Nomad

ALERT SERVICE BULLETIN

STRUCTURE ASSEMBLY — FUSELAGE — REAR — INSPECTION, REPAIR AND INCORPORATION OF MOD N806 (REAR FAIRING STRENGTHENING)

Figure 4 Fitment of Spacers in Rear Fairing

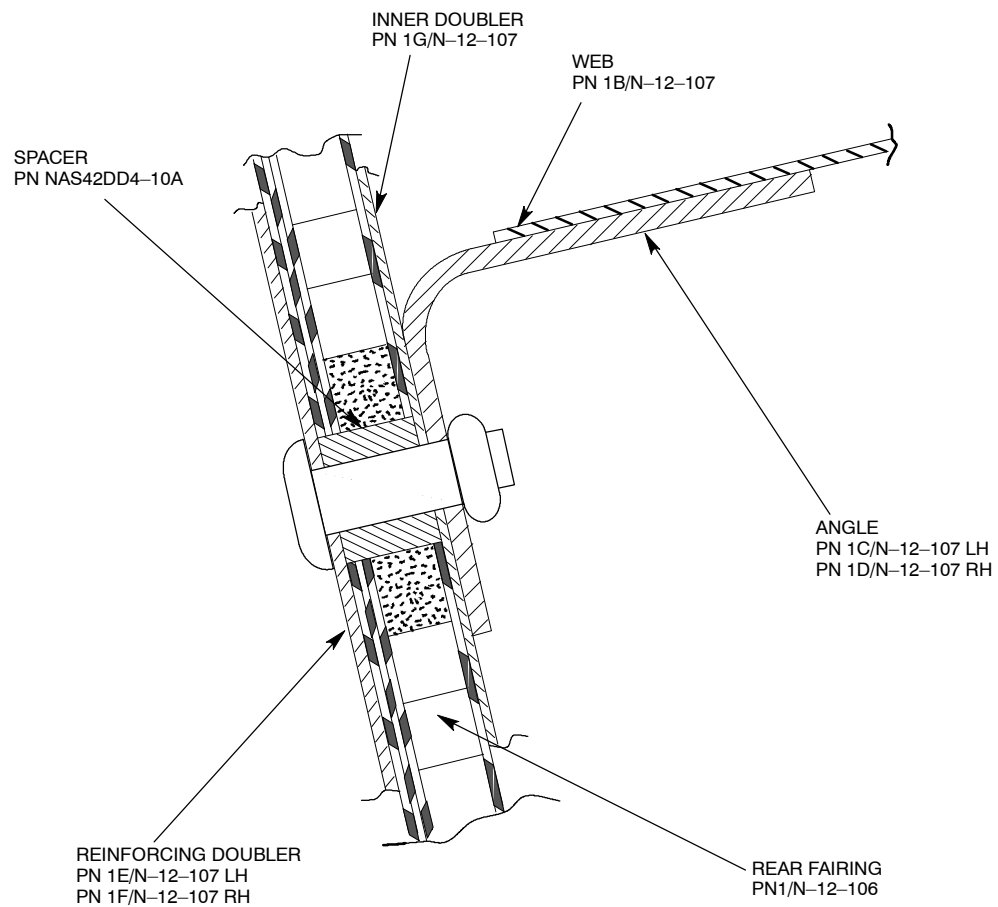
- (16) Remove clamped up assembly of angles, web and 'zee' angles and open up the holes in rear fairing to 17/64 in.
- (17) Bond Spacers PN NAS42DD410A into the holes in rear fairing using Araldite AW106/HV953U or alternately use a K106 kit (Ref Figure 4). Allow to cure.

- (39) Remove rear fairing and open up holes to 17/64 in.
- (40) Bond Spacer PN NAS42DD410A into the holes in rear fairing using Araldite AW106/HV953U or alternately use a K106 kit (Ref Figure 4). Allow to cure.

Figure 5 Web, Angle and Zee Angle Assembly

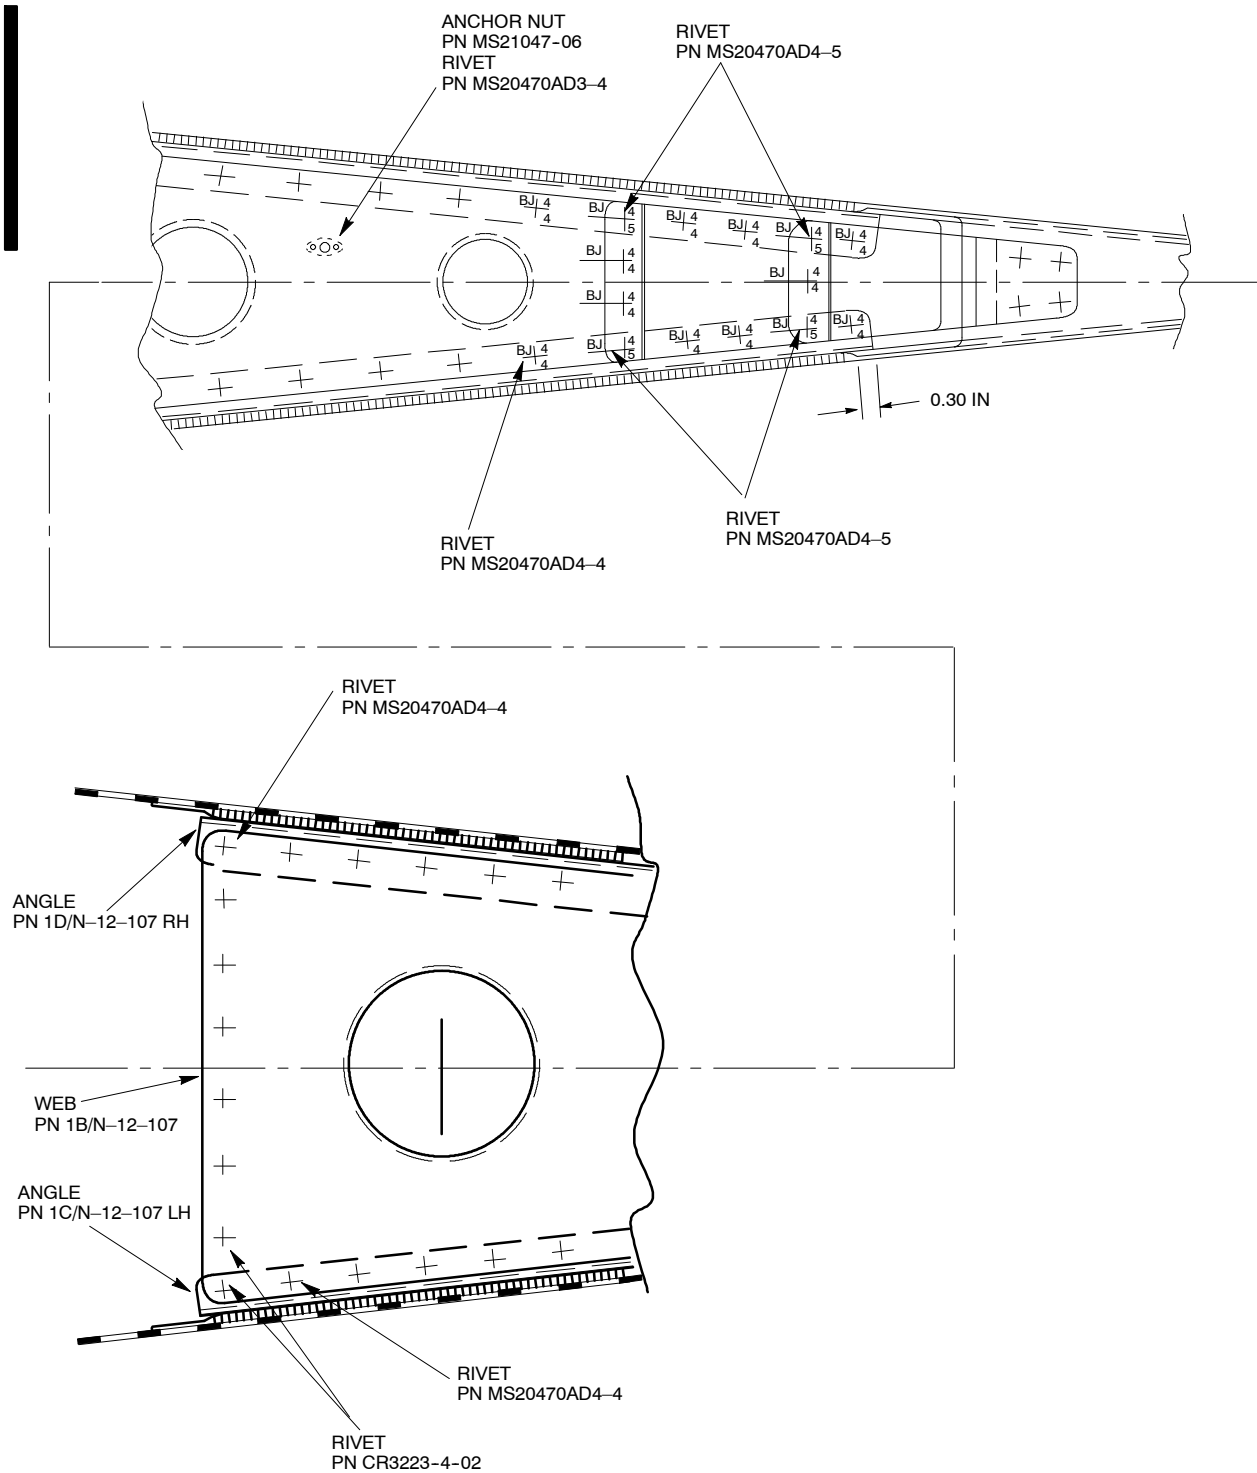
- (27) Attach reinforcing plate to top diaphragm with 6-off rivets PN NAS1097AD4-4 and 4-off rivets PN CR3222-4-02 (Ref Figure 6). Install rivets wet.
- (28) Wet assemble and rivet up web, LH and RH angles, and 'zee' angles to Angle PN 1U/N-12-195 and top diaphragm. (Ref Figs 3, 5, 6 and 7).

Figure 6 Web and Reinforcing Plate Attachment to Top Diaphragm

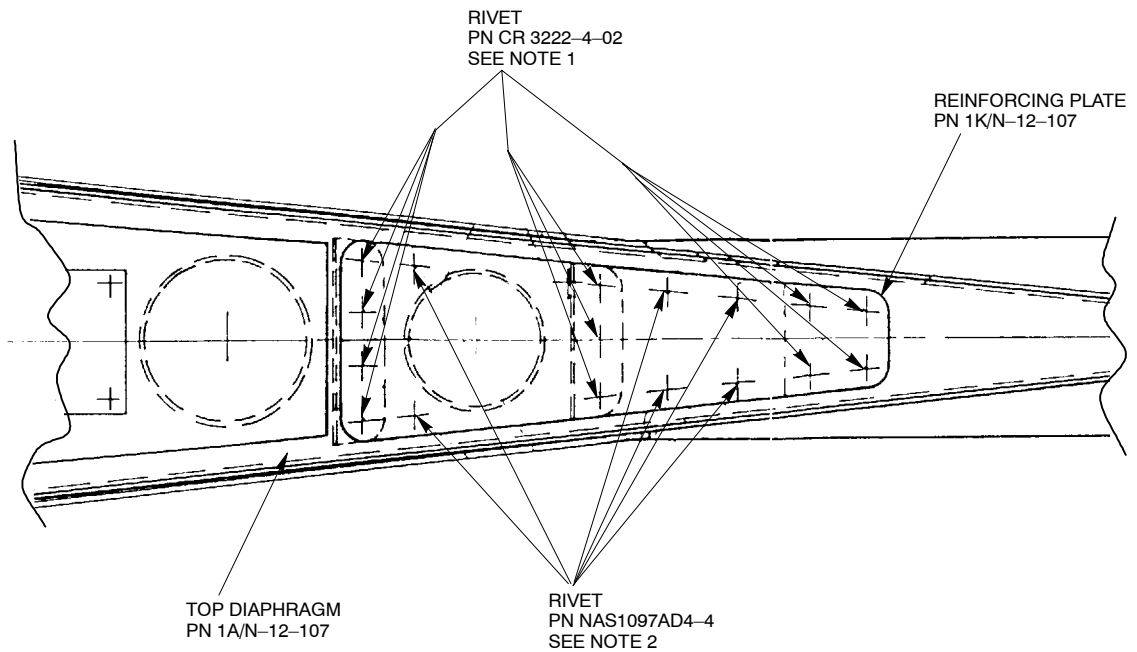
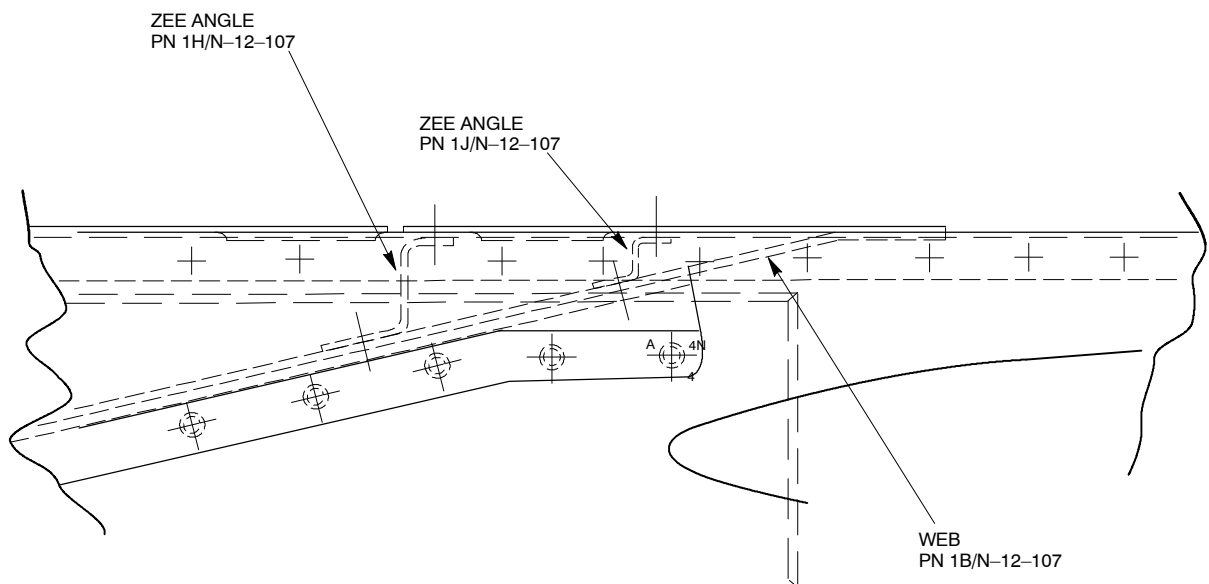
- (24) Mark out in the top diaphragm, four rivet holes for the forward 'zee' angle and three rivet holes for the aft 'zee' angle, drill and deburr (Ref Figure 6).

- (25) Locate Reinforcing Plate PN 1K/N-12-107 on top diaphragm. Ensuring correct edge distance, drill eleven through holes plus six additional holes. (Ref Figure 6).

1. RIVET ZEE ANGLES TO TOP DIAPHRAGM.
2. WET ASSEMBLE REINFORCING PLATE TO TOP DIAPHRAGM.

Figure 7 Attachment to Rear Fuselage

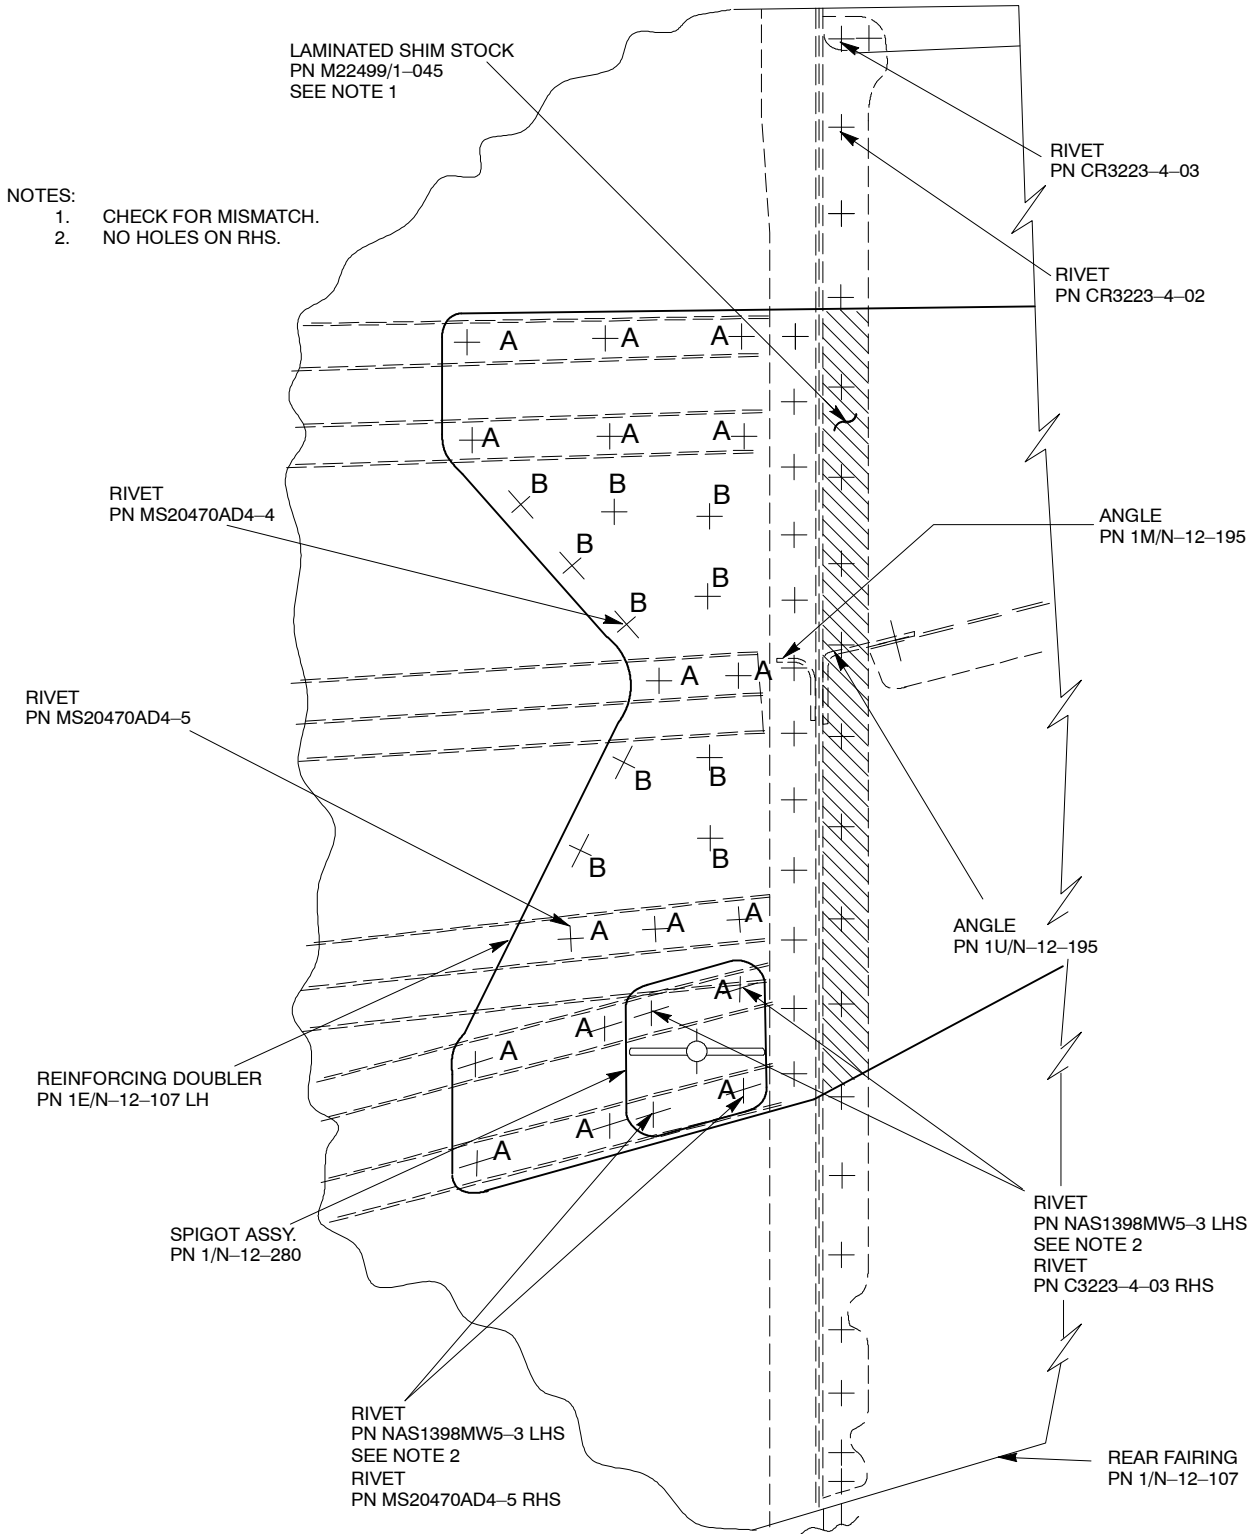
- (43) Drill out rivets identified by 'A' in Figure 7.
- (44) Pin rear fairing to aircraft.
- (45) Fit Packer PN 1/N-12-434 between reinforcing doubler and rear fuselage skin. Trim where necessary.

- (46) Backdrill all holes marked A (Ref Figure 7) into packer and reinforcing doublers LH and RH or alternatively make a template from perspex for hole pick up.

- (47) Drill all holes marked B in (Ref Figure 7) through reinforcing doubler into packer and rear fuselage skin.
- (48) Skin pin reinforcing doublers and packers to rear fuselage.

- (49) Check for any mismatch at abutment of fuselage and rear fairing, LH and RH side shaded area in Figure 7. Mismatch is not to exceed 0.020 in.
- (50) If necessary pack mismatch with Laminated Shim Stock PN M22499/1-045, approximately 0.70 in wide, between reinforcing doubler and rear fairing. Peel laminations as required to within mismatch requirements.

- (53) Replace rear fairing, packers and cover strips, and hold in position with skin pins.
- (54) Wet assemble and rivet-up according to Figure 7. Install rivets wet. Alternately, where access is limited, Cherrymax rivets PN CR3223-4 may be used.

Figure 8 Access Panel Installation

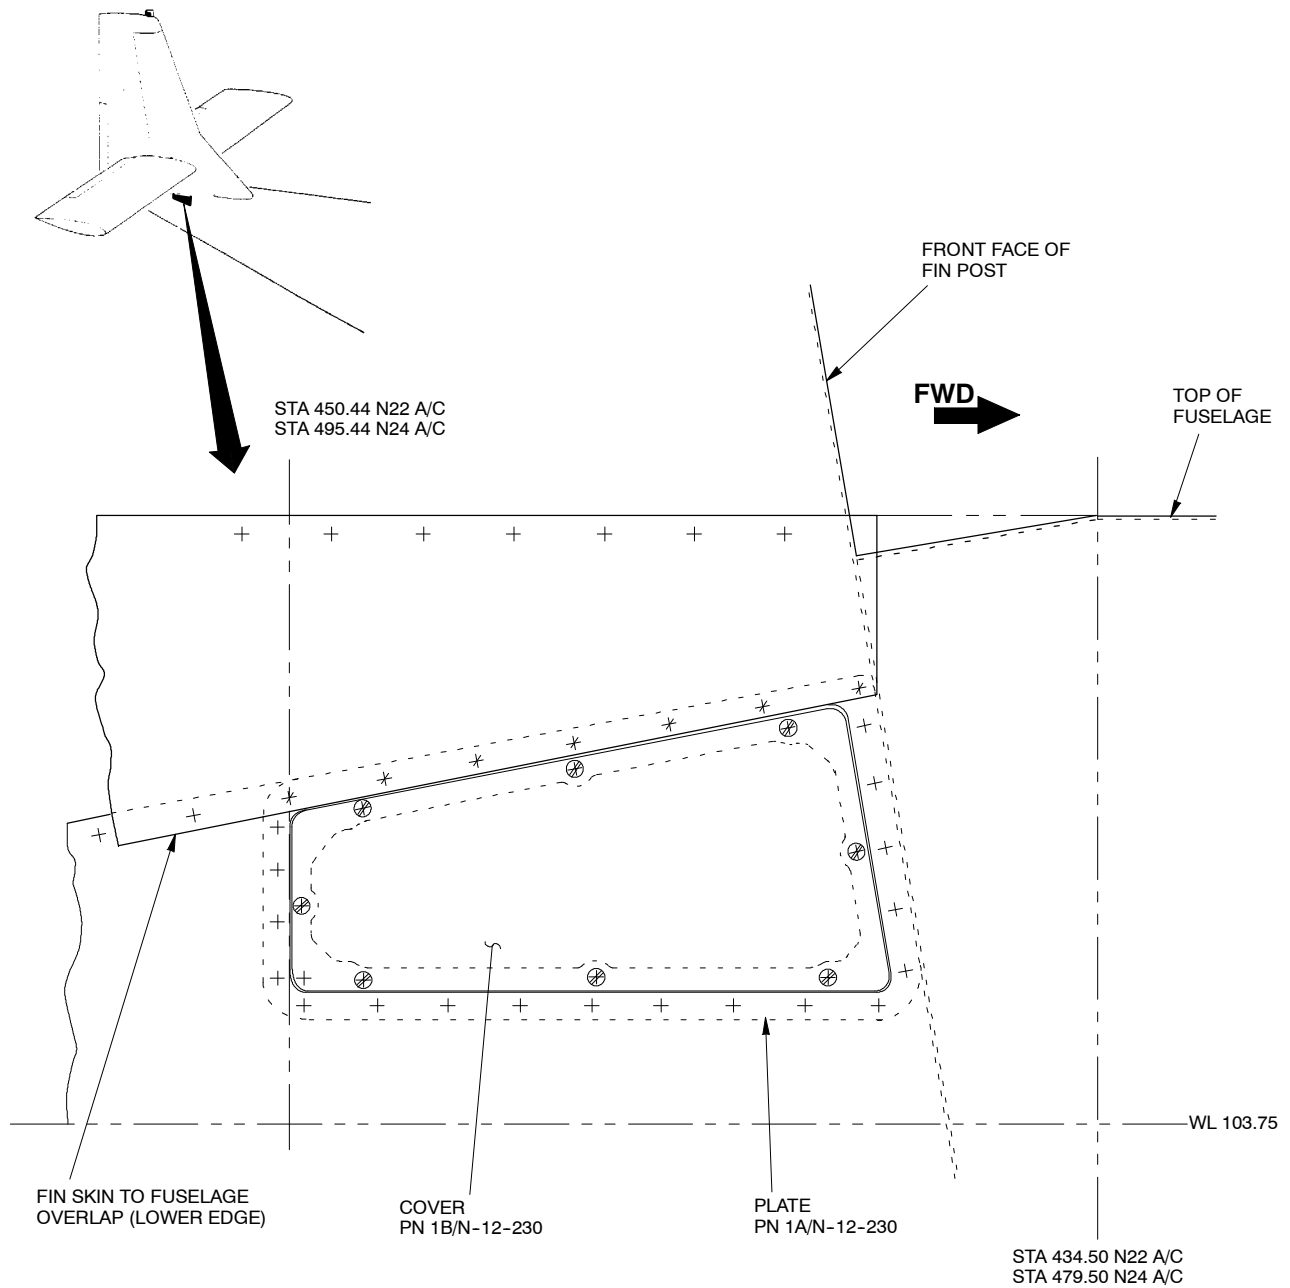
D. Part 4- Optional Installation of Rear Access Panel PN 1/N-12-230 (Ref Figure 8)

- (1) On RH side of aircraft mark reference line at STA 450.44 for N22 series aircraft or STA 495.44 for N24 series aircraft on the outer skin.
- (2) Using cover PN 1B/N-12-230 as a template, align LH edge to reference line at STA 450.44 for N22 series aircraft, or STA 495.44 for N24 series aircraft, and rest the top edge against lower edge of the fin skin to fuselage overlap (Ref Figure 8), mark cutout.

Figure 9 Access Panel Doubler Plate Installation

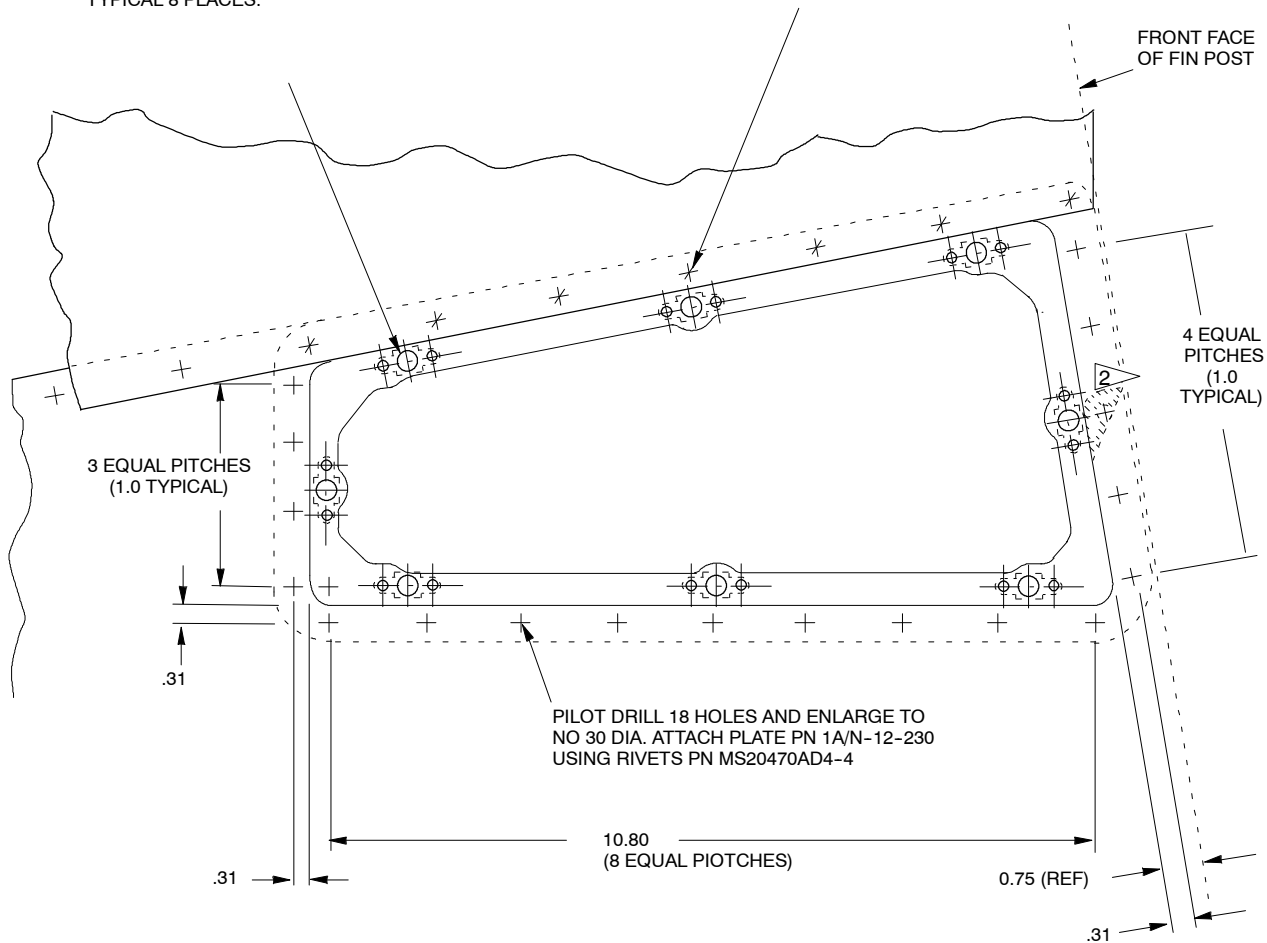
- (6) Back drill 7 holes (from Para (4)). Pilot drill remaining 18 rivet holes as per drilling pattern in Figure 9, through outer skin and plate. Enlarge rivet holes using No.30 dia drill. Remove plate and deburr holes.

ENLARGE HOLE TO 0.50IN DIA AND CENTRALLY LOCATE CAMLOC RECEPTACLE. DRILL 2 HOLES 2.45MM DIA AND COUNTERSINK. ASSEMBLE RECEPTACLE TO PLATE USING RIVETS PN MS20426AD3-4 . TYPICAL 8 PLACES.

REMOVE EXISTING RIVETS (7 OFF). BACK DRILL THROUGH SKIN INTO PLATE PN 1A/N-12-230 AND SIZE TO NO 30 DIA. ATTACH PLATE USING RIVETS PN MS20470AD4-5
